SUBJECT: Transmittal of Revised Responses to AP1000 DSER Open Items

AP1000 Design Certification Review
Draft Safety Evaluation Report Open Item Non-Proprietary Responses

DSER Open Item Number: 3.8.2.1-1 Revision 2

DSER Open Item Number: 19.1.10.1-5 (Response Revision 2)

Figure 19A.2-8-4: Floor Response Spectra of ASB Node at EL. 116.50'

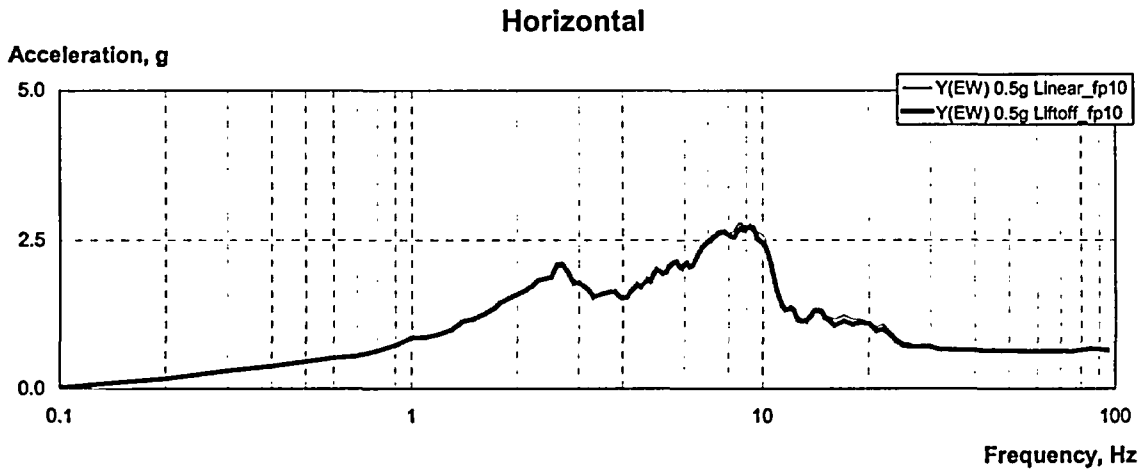
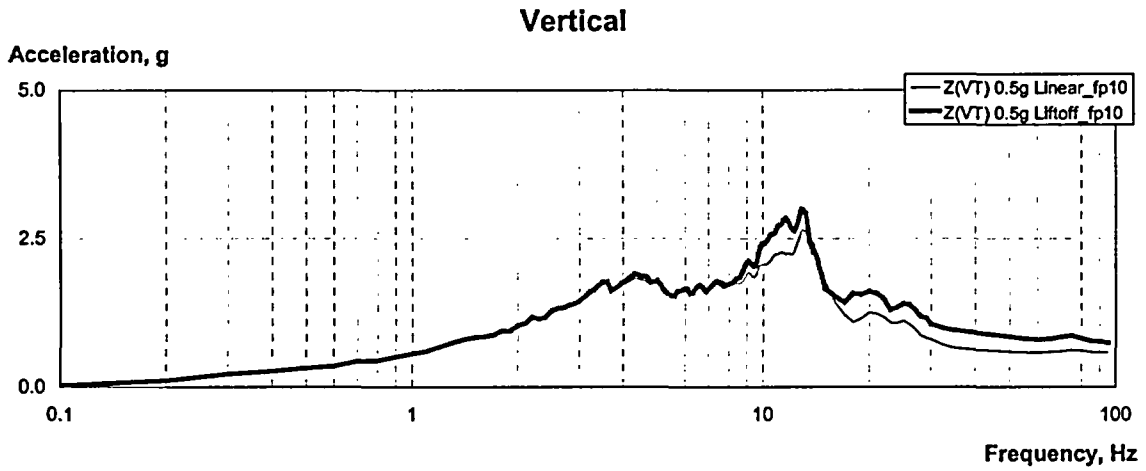
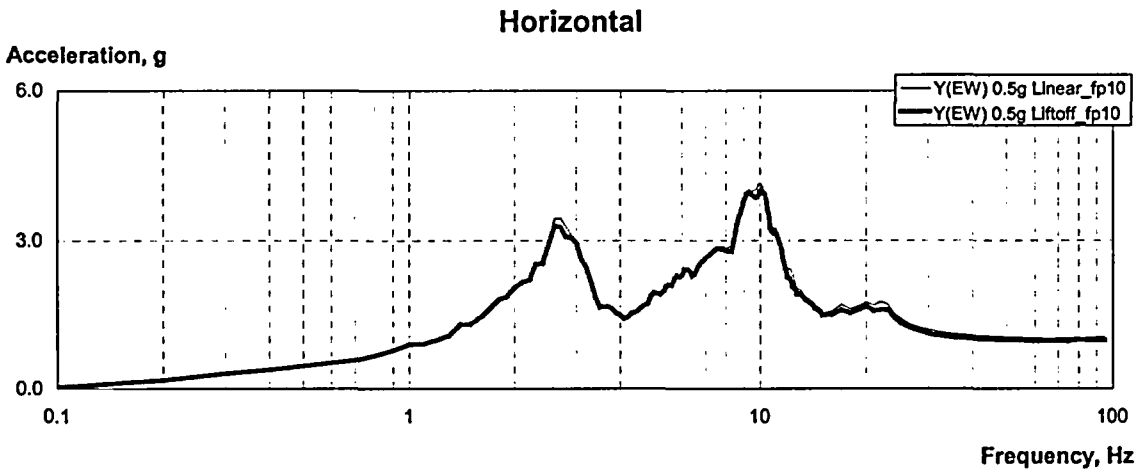
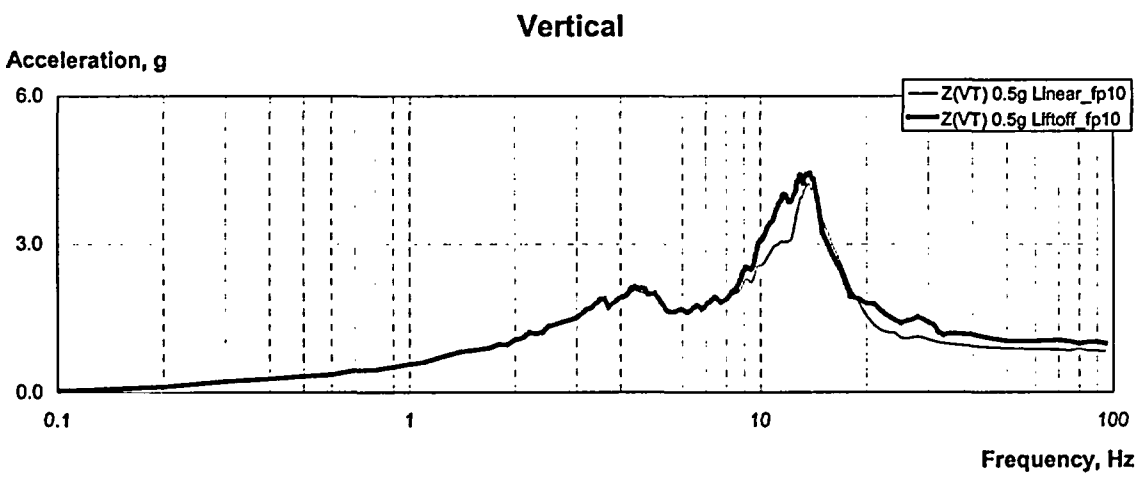
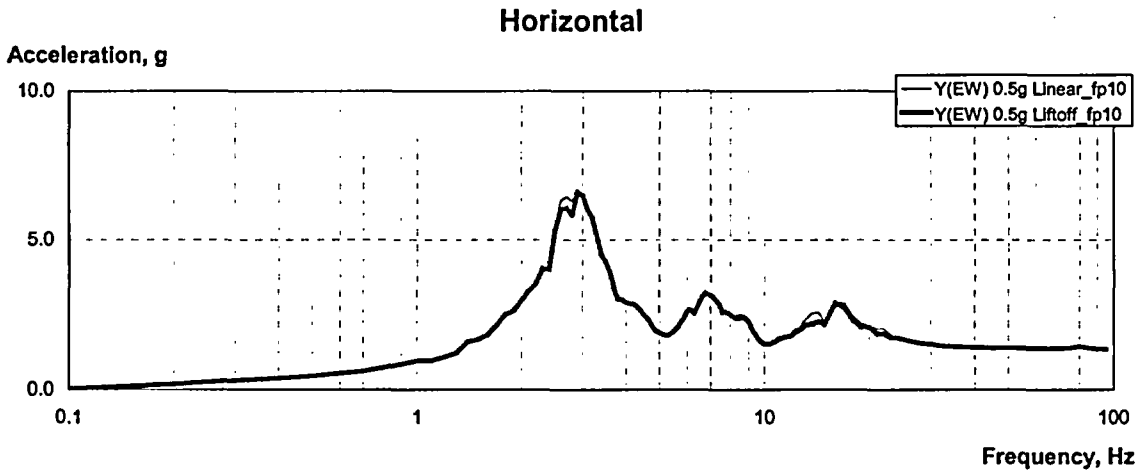
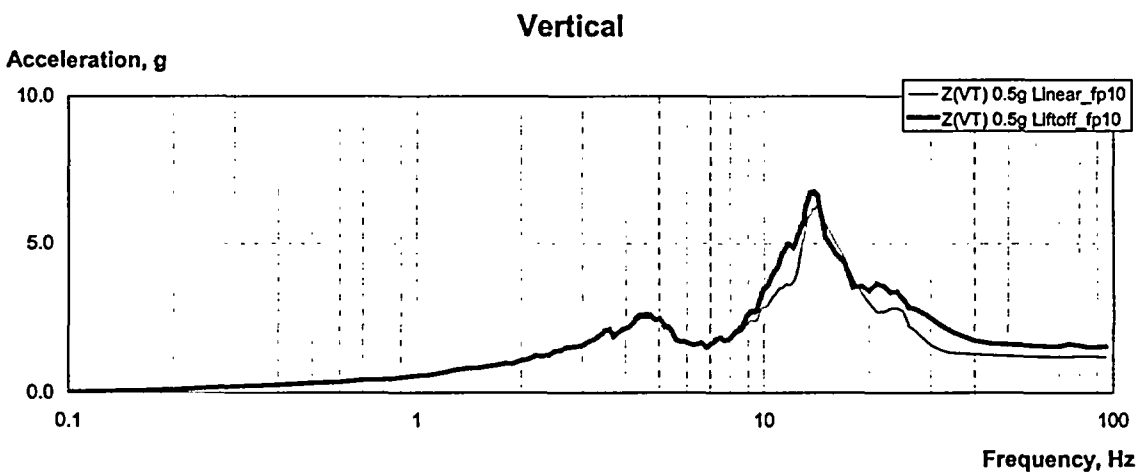
Westinghouse has not adequately justified that the effect of lift off of the nuclear island basemat is not significant in the seismic margin evaluation. The results that are presented in the Revision 1 response may cause the HCLPF values to fall below the review level earthquake of 0.5g. Further, the CIS lift off with the nuclear island basemat uplift may make the seismic response worse. Westinghouse has not presented results from a combined model with liftoff from the CIS and nuclear island basemat to demonstrate that the results are not higher than those presented.

Figures 19A.2-8-4 to 19A.2-8-8 compare the response spectra from the non-linear analyses (with lift-off) against those from linear analyses (no lift-off). The comparison shows that the effect of liftoff on the horizontal seismic response is insignificant. There are small differences in the vertical response spectra in the higher frequency region for the Shield Building cylinder up to elevation 265'. The effects of lift off are much less than in the analyses described in the Revision 1 response.
